City of Glendale
Community Development Department
Design Review Staff Report – Multi-Family

Meeting/Decision Date: October 11, 2021	Address: 3419 Montrose Avenue
Review Authority: <input type="checkbox"/> DRB <input checked="" type="checkbox"/> ADR <input type="checkbox"/> HPC <input type="checkbox"/> CC	APN: 5607-004-032
Case Number: PDR2106786	Applicant: Helbert Moradian
Prepared By: Danny Manasserian, Planning Associate	Owner: Arbita Nersesian

The applicant is proposing to construct additions at the front and rear of the existing house, build a new two-story residential unit and garages behind the house, and demolish the existing garage. The property is located in the R-3050 (Moderate Density Residential) zone.

PROPOSED SOUTH ELEVATION
1/4"=1'-0"

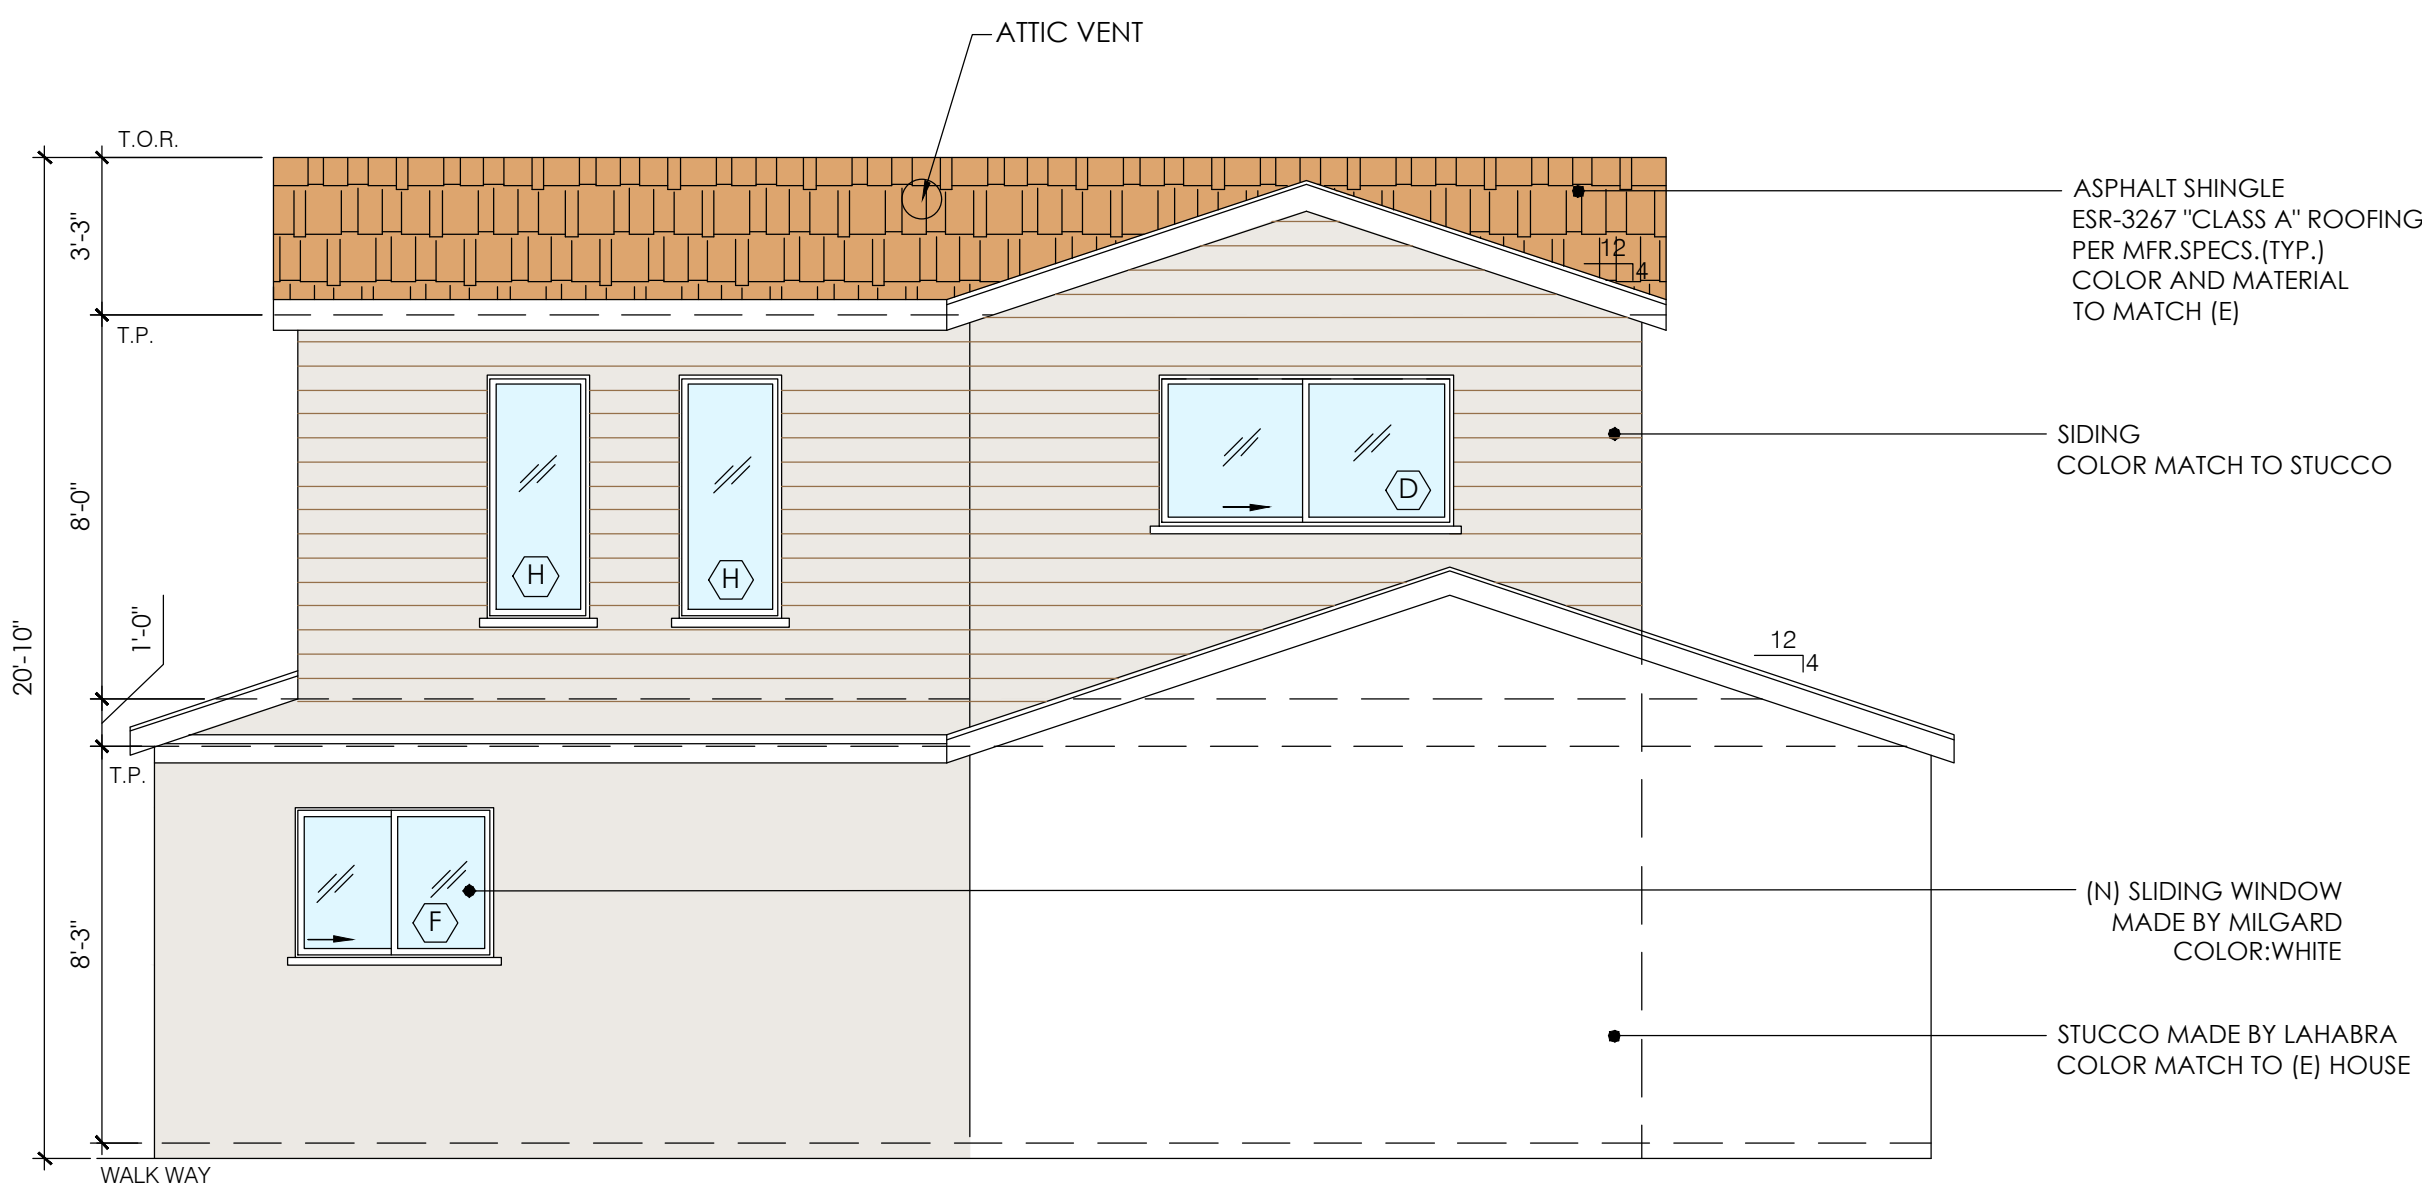
The design will be enhanced if the siding color is somewhat darker, rather than the same as, the color of the walls. A condition to this effect is added.

- The traditional design of the new unit is appropriate to the neighborhood and the existing house.
- The placement of the proposed cement fiber siding on the new unit is appropriate, however, as proposed, the color is the same as the stucco. A condition has been added to choose a somewhat darker color to complement the white stucco.
- All windows will be vinyl, recessed with a wood sill and frame to match the proposed windows on the front house. As proposed, the windows are appropriate to the design and the neighborhood in terms of their operation and overall appearance.
- The roof material includes brown composition shingle, matching the front house.

1. Propose somewhat darker color for cement fiber siding at new unit for staff review.
